Re: Draft National Pollutant Discharge Elimination System (NPDES) General Permit for the Eastern Portion of the Outer Continental Shelf (OCS) of the Gulf of Mexico (GEG460000) (81 Fed. Reg. 55,196 (August 18, 2016)).

**RE: Offshore Operators Committee Comments  
Notice of Proposed National Pollutant Discharge Elimination System (NPDES)  
General Permit for New and Existing Sources in the Offshore Subcategory of the  
Oil and Gas Extraction Category for the Eastern Portion of the Outer Continental  
Shelf (OCS) of the Gulf of Mexico (GEG460000), Public Notice No. 16AL00001.**

## Draft NPDES General Permit for New and Existing Sources in the Offshore Subcategory of the Oil and Gas Extraction Category for the Eastern Portion of the Outer Continental Shelf of the Gulf of Mexico (GEG460000)

### GEG460000 August 18, 2016 Draft Renewal Permit, Public Notice No. 16 AL00001 – Offshore Operators Committee Comments

Example drain system isometric drawing for offshore platform- vertical pipe stubs connect to collection systems (e.g. skid pans). Effluents are collected and routed to presumpt and/or sump pile emergency sump (not shown on diagram- see example flow diagrams)

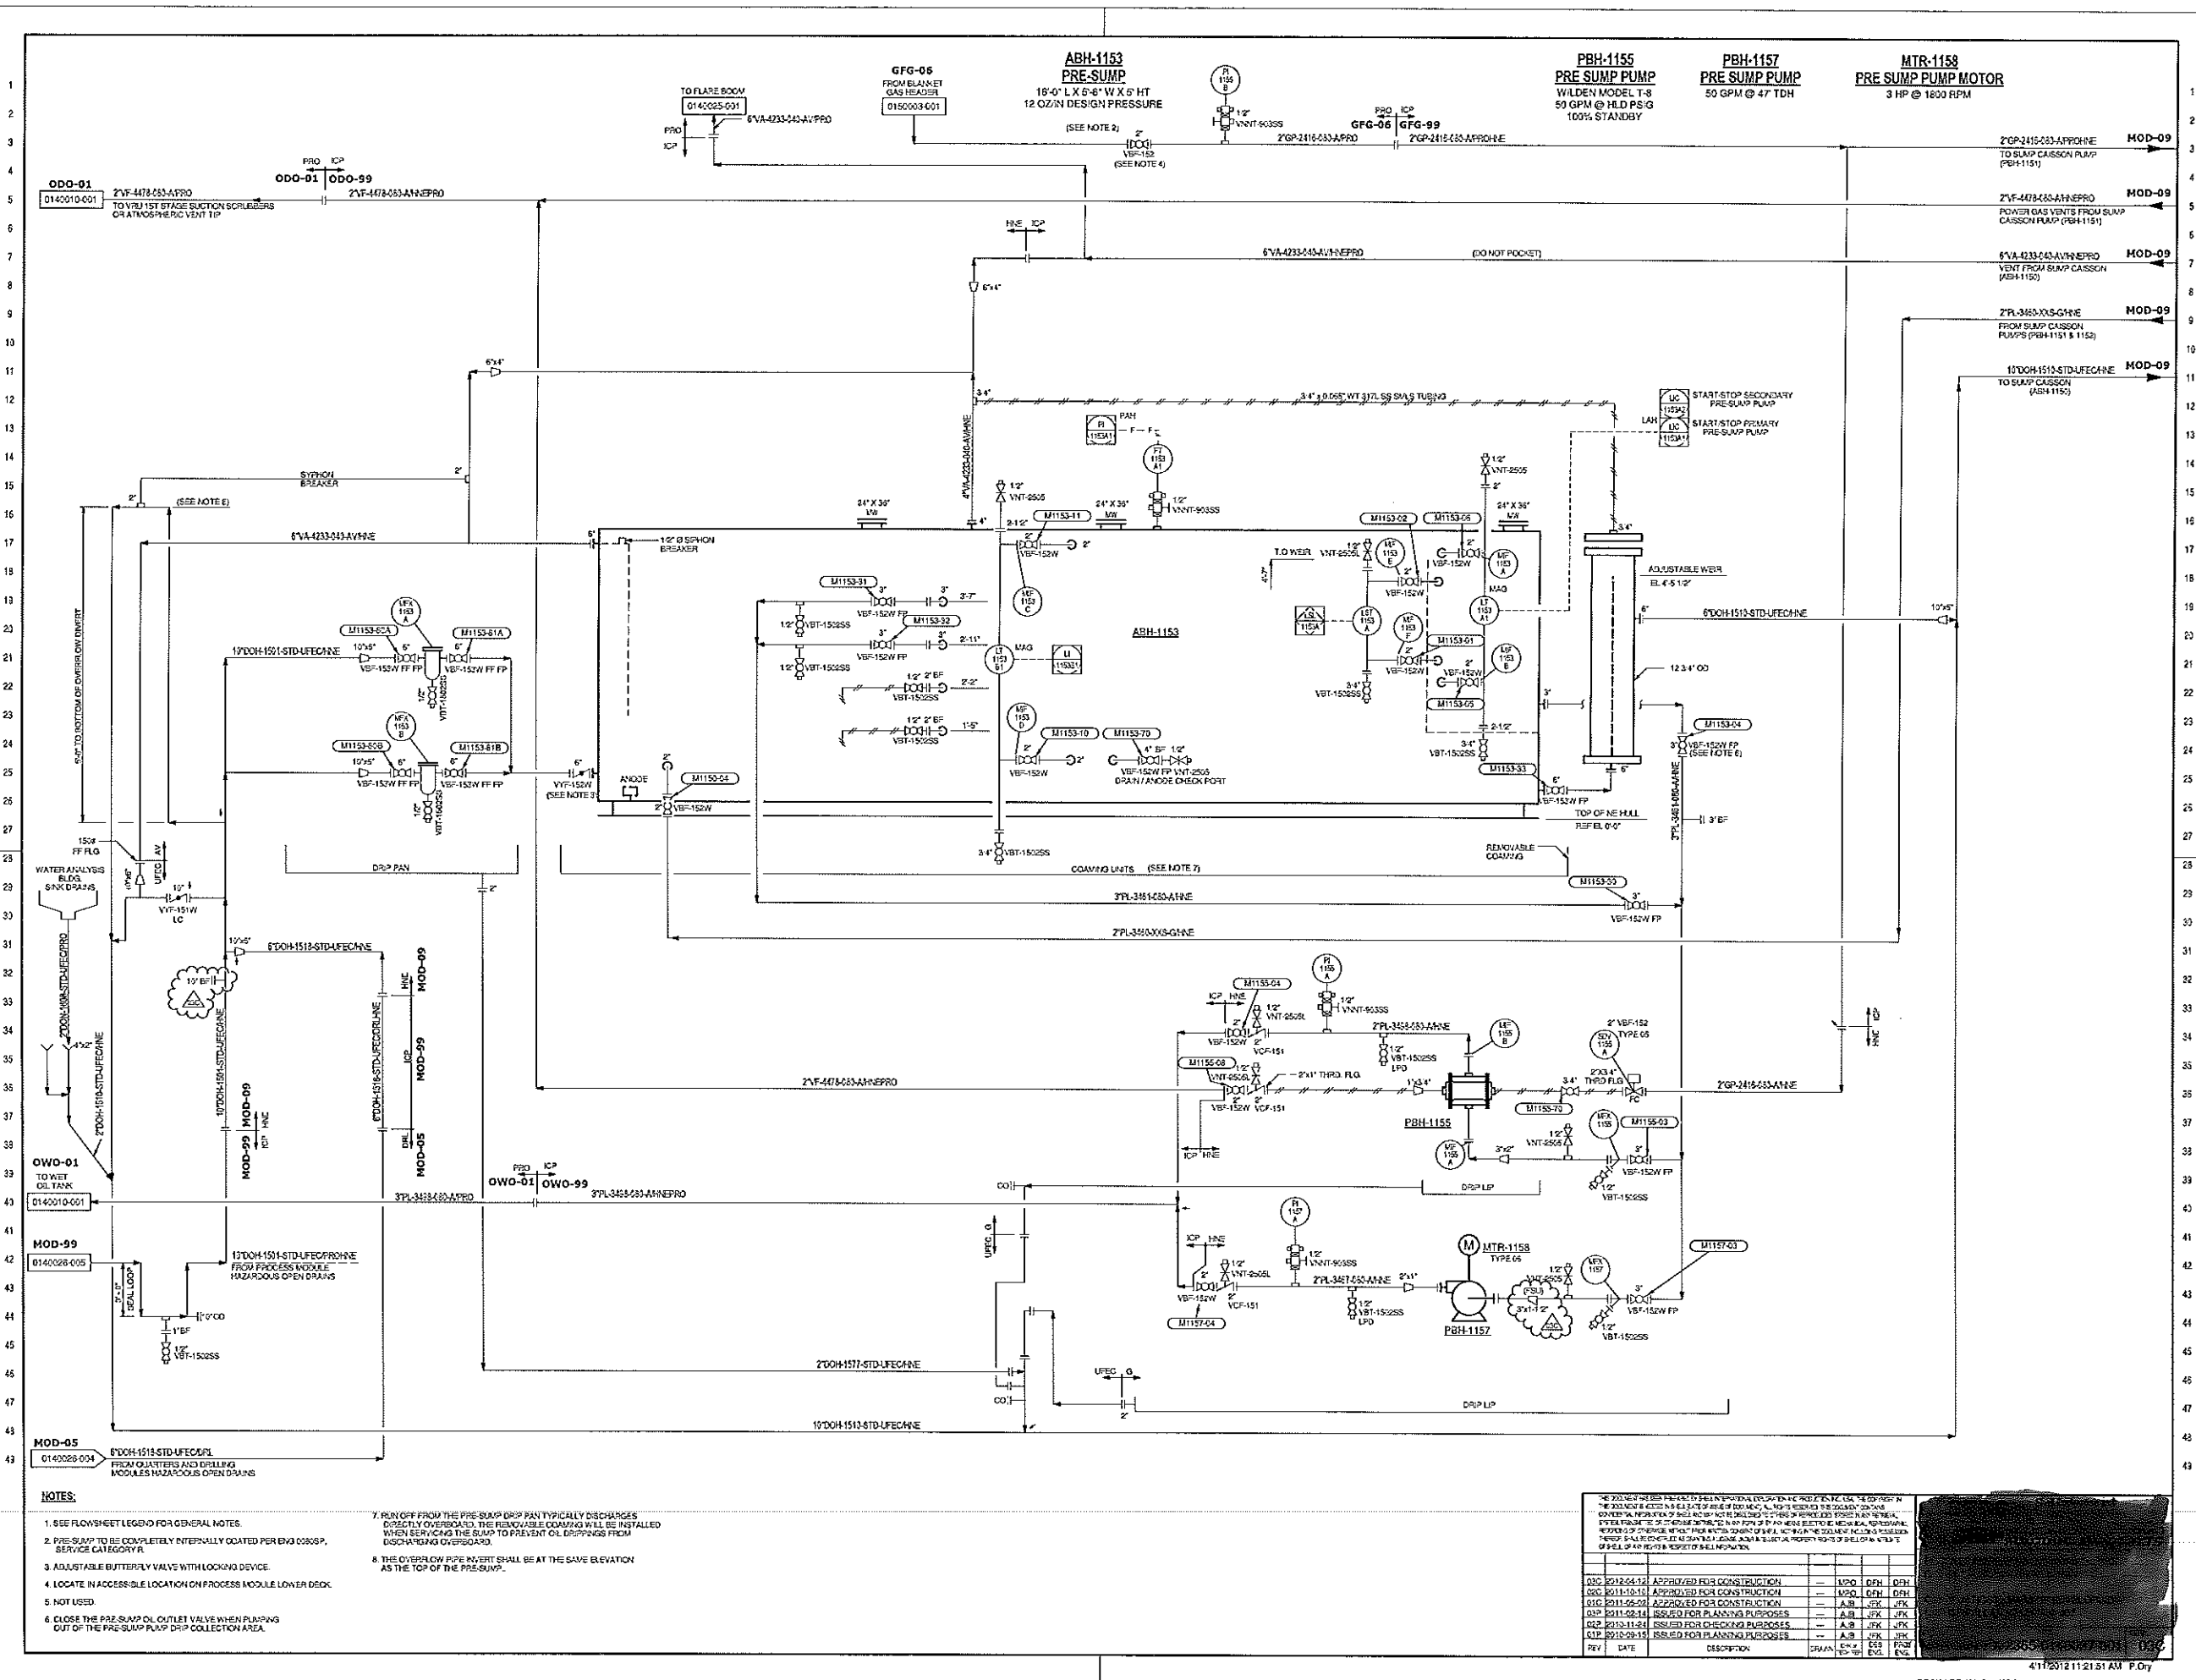
**COMMENT NO. 4**
